ADDENDUM NO. 2

Westside Library Relocation Project

Addendum #2

Westside Library Expansion Project

COVER SHEET

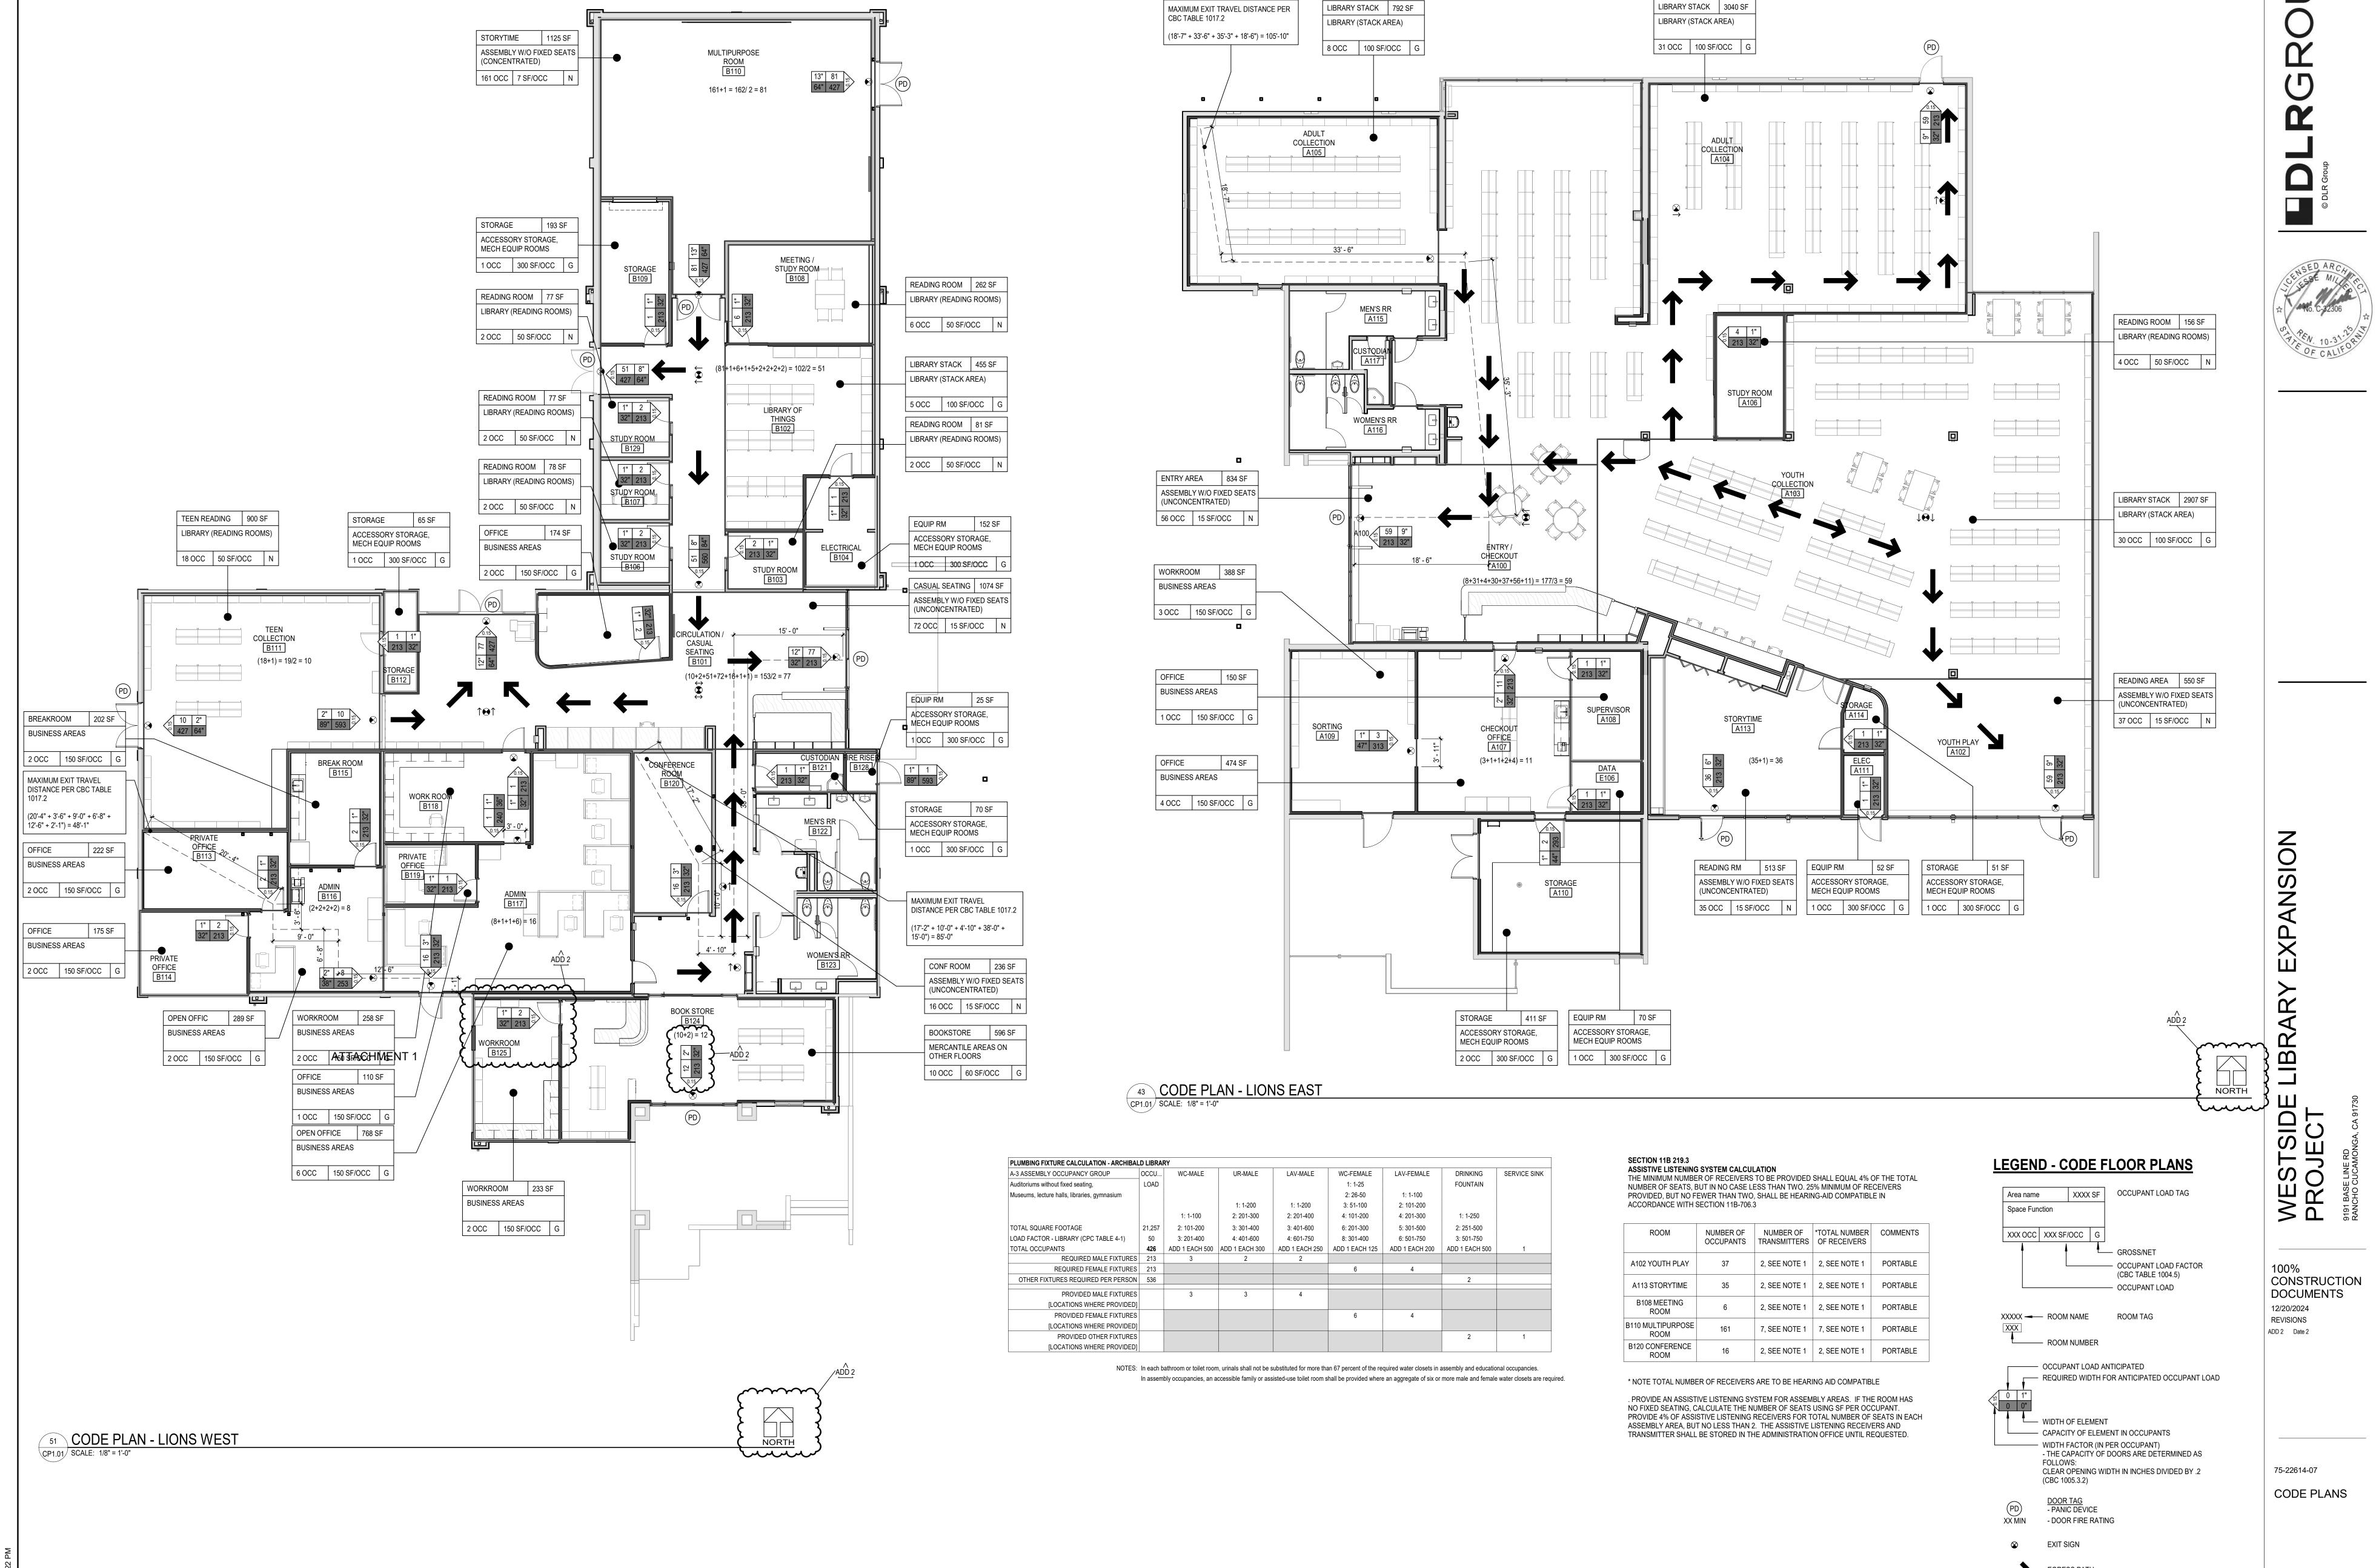
ITEM A-2.01 SHEET G0.1 – COVER SHEET

- 1. UPDATING TITLE TO "WESTSIDE LIBRARY EXPANSION PROJECT"
- REMOVING LANGUAGE OF SCOPE OF WORK ITEM 3B AS NORTHWEST PARKING AREA SCOPE WAS REMOVED IN ADDENDUM 1.
- REMOVING 'ADD ALTERNATE' LANGUAGE FROM CANOPY SCOPE AS IT IS PART OF SCOPE.

CP1.01

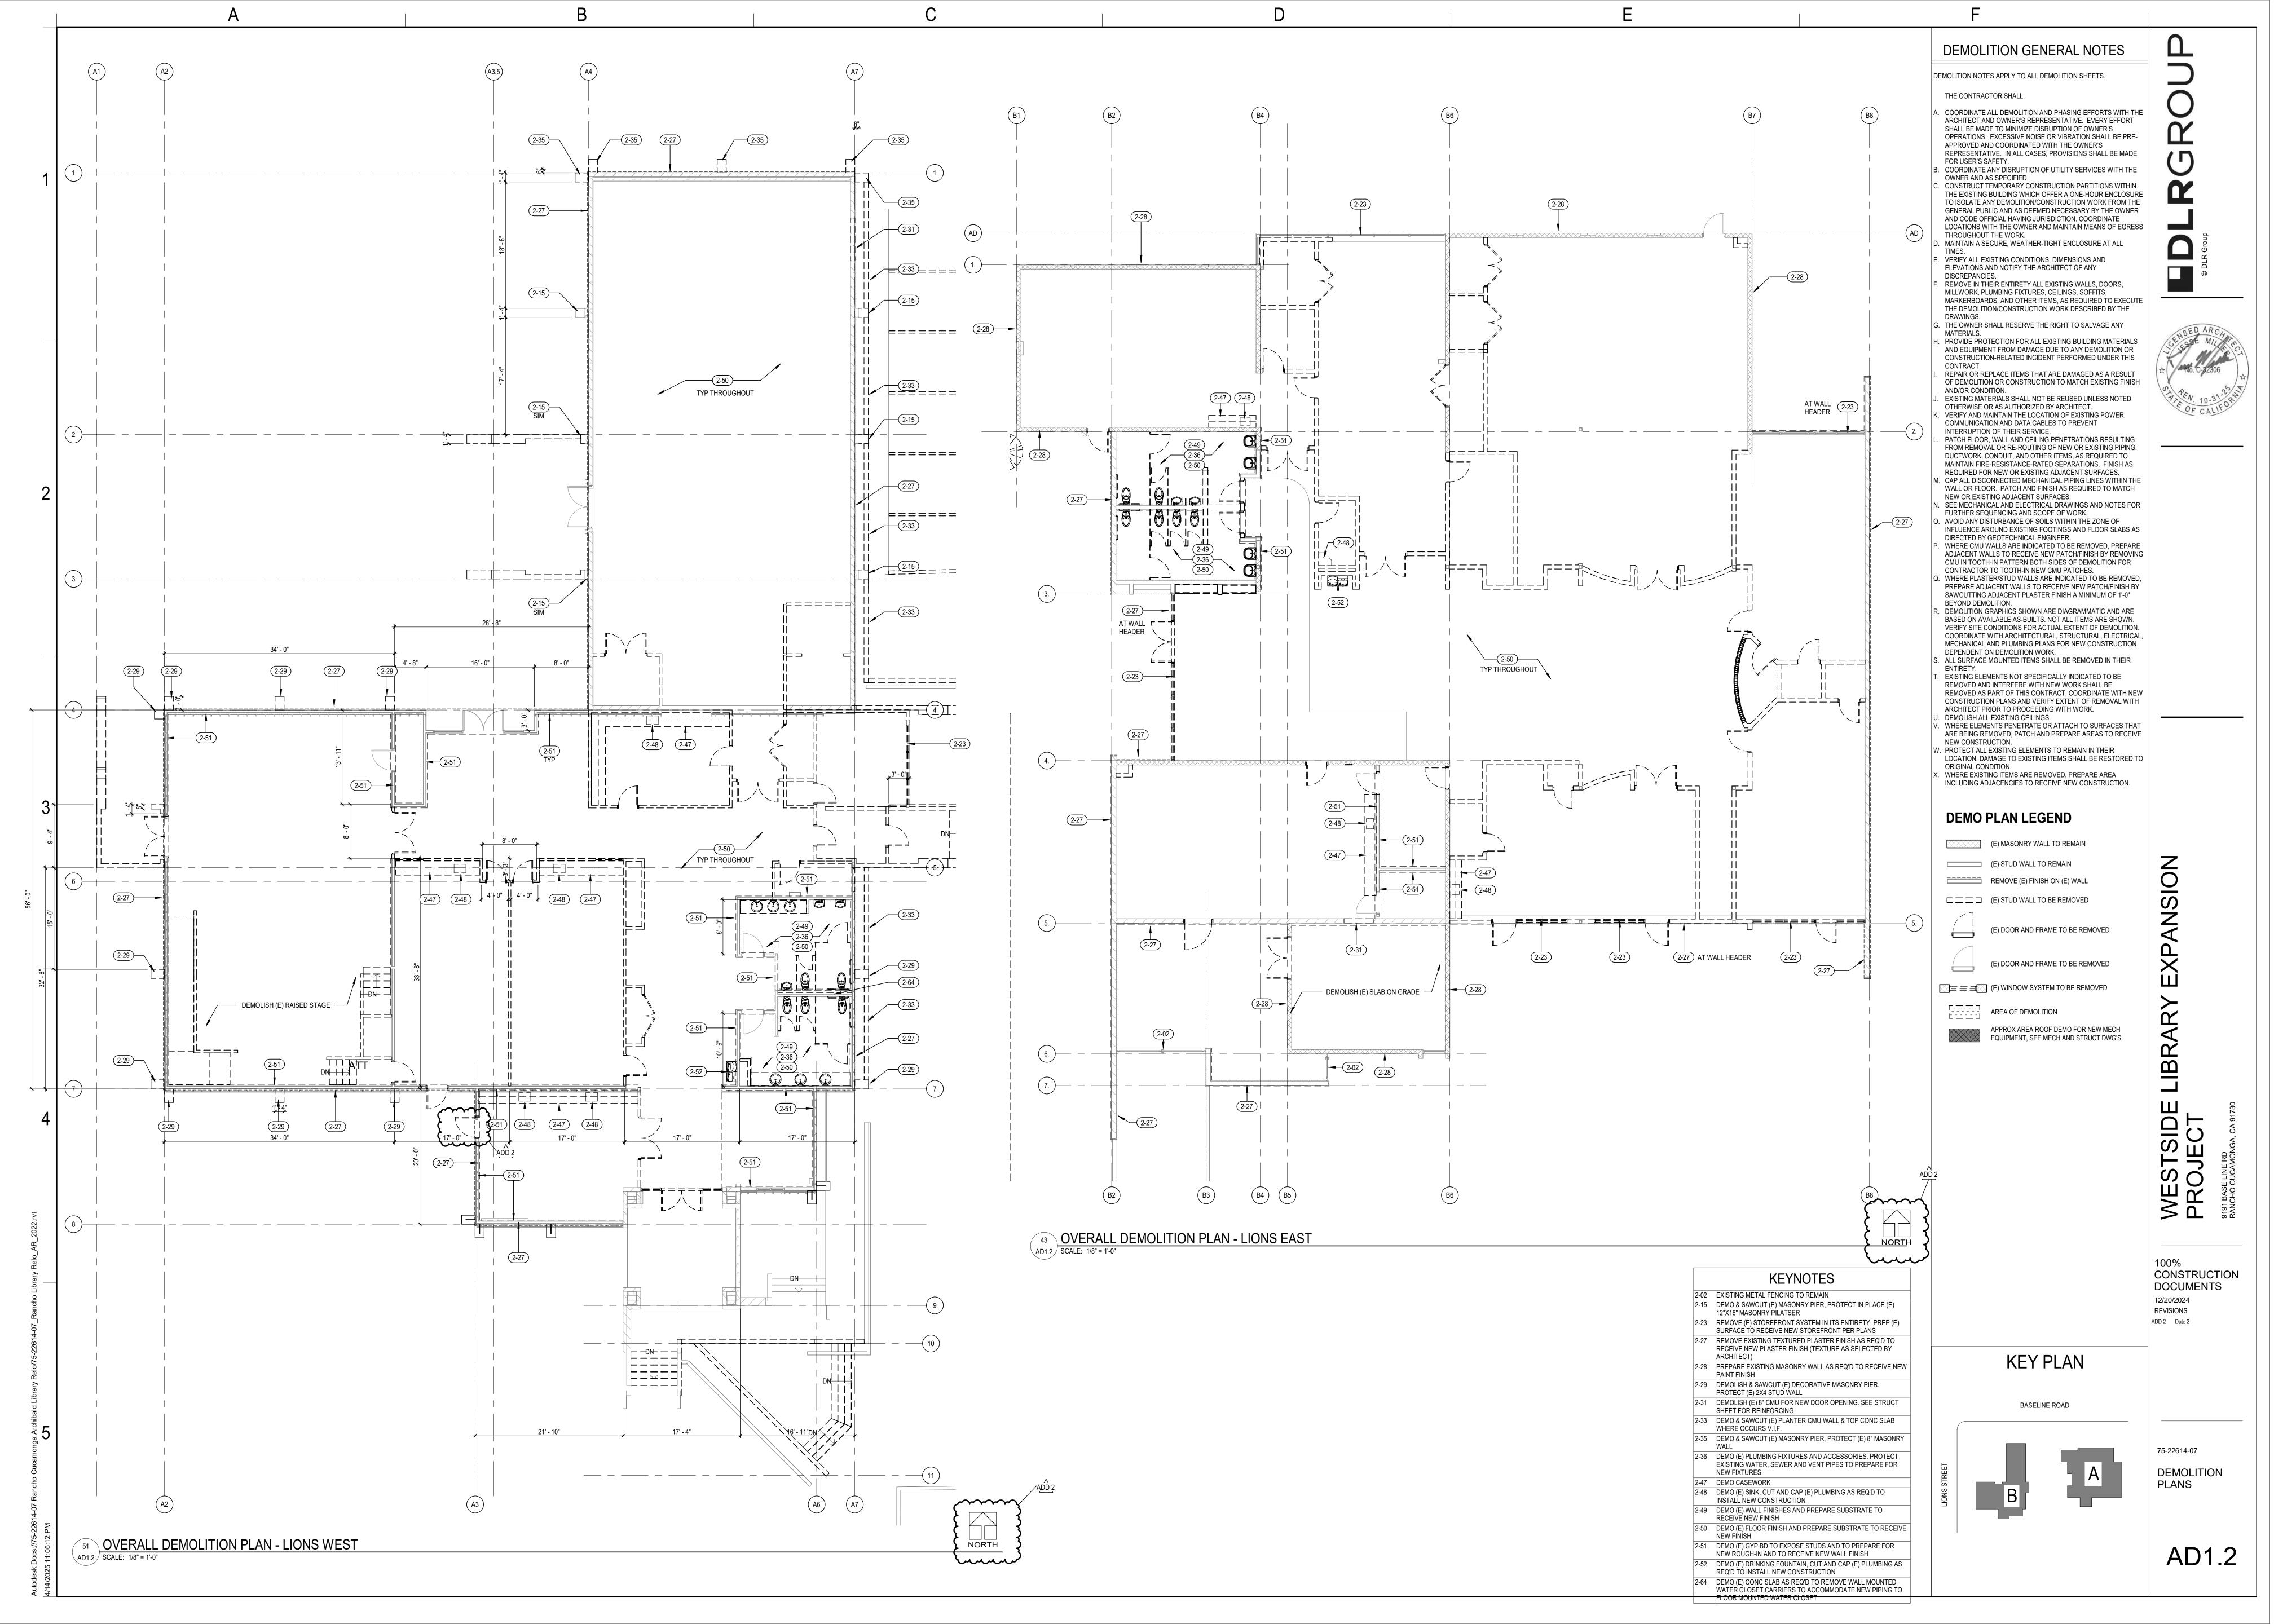
ITEM A-2.02 SHEET CP1.01 – CODE PLANS

- 1. RELOCATING THE EGRESS OF ROOM B125 TO THE EAST.
- 2. ADDING NORTH ARROW.

WEST BUILDING **EXTERIOR DEMO ELEVATIONS**

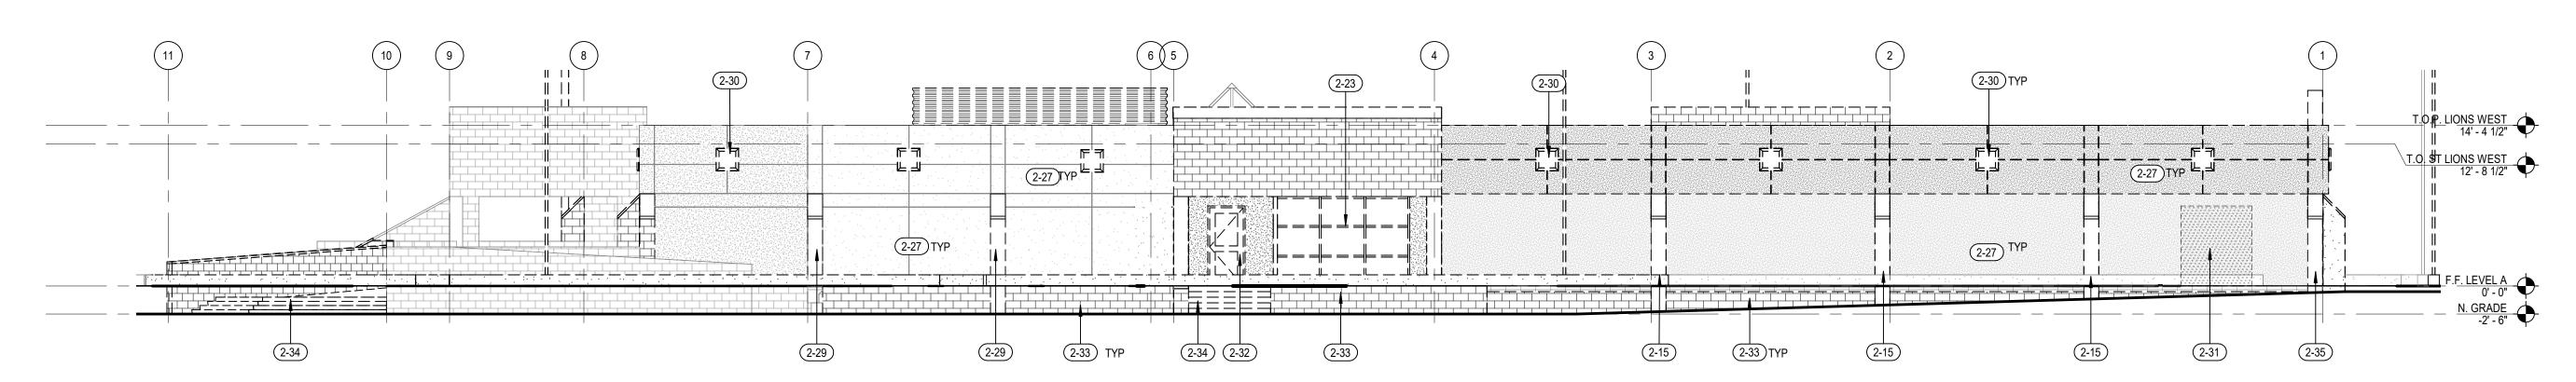
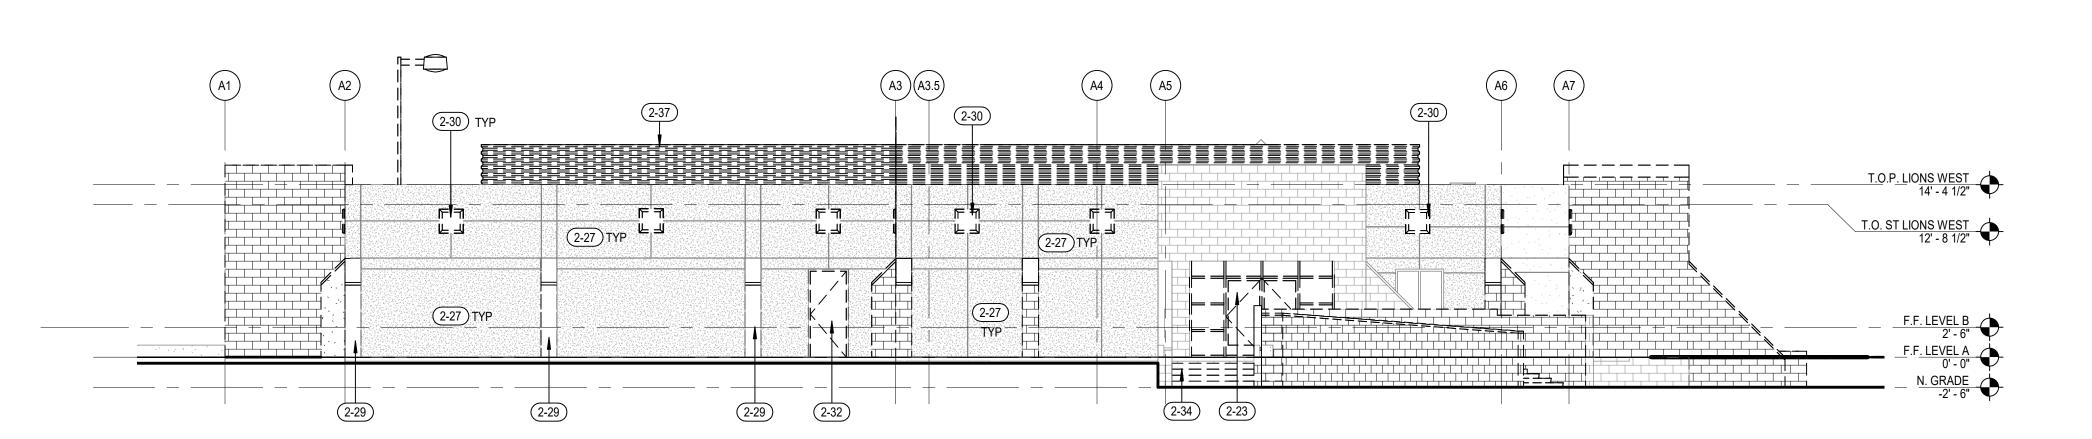
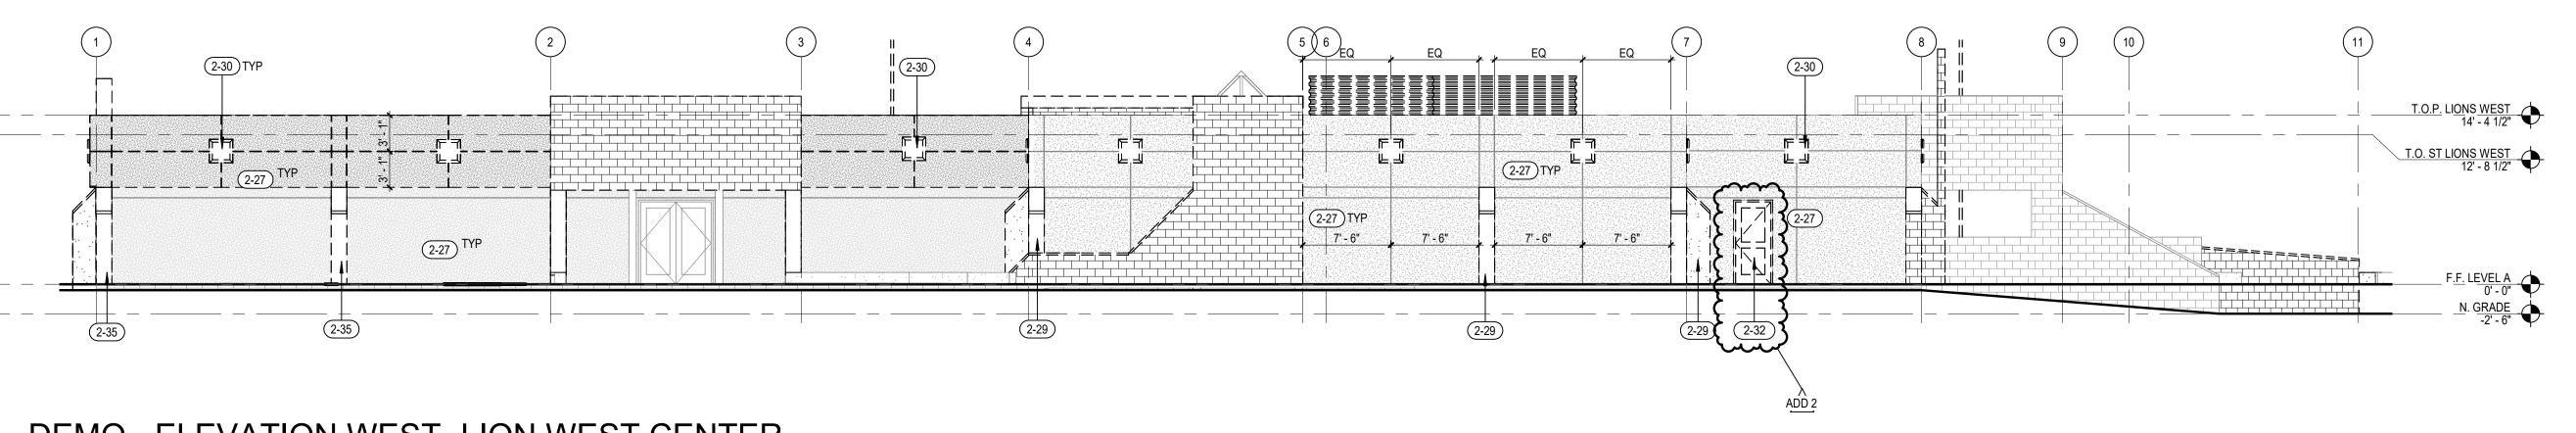
ITEM A-2.04 SHEET AD4.2 – WEST BUILDING – EXTERIOR DEMO ELEVATIONS

1. INDICATING THE DEMOLITON OF DOOR B124C.
